Report: Punch List
Function: Test, Adjust, & Balance
Date: 12/09/2025
Completed By: National TAB

PROJECT
12-08-25 FREDDYS MIDDLETOWN, DE

Project: 12-08-25 FREDDYS MIDDLETOWN, DE

- RTU 1 low flow

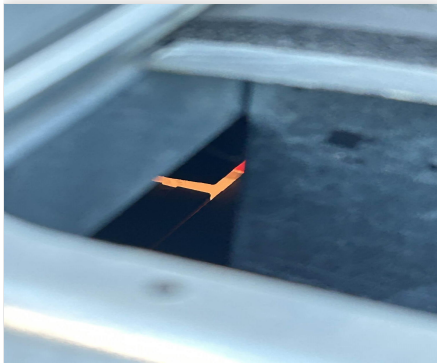
Issue Name : RTU 1 low flow
Description : RTU 1 supply drop has a 4" opening and is not properly attached to discharge. Unit is losing air inside the ceiling.
Created By : National TAB **Assigned To :** National TAB - Dan Hertenstein
Status : Open
Priority : Urgent **Asset Tag :** RTU1
Originated Date : 12/09/2025 - Jearod Ferrette - National TAB
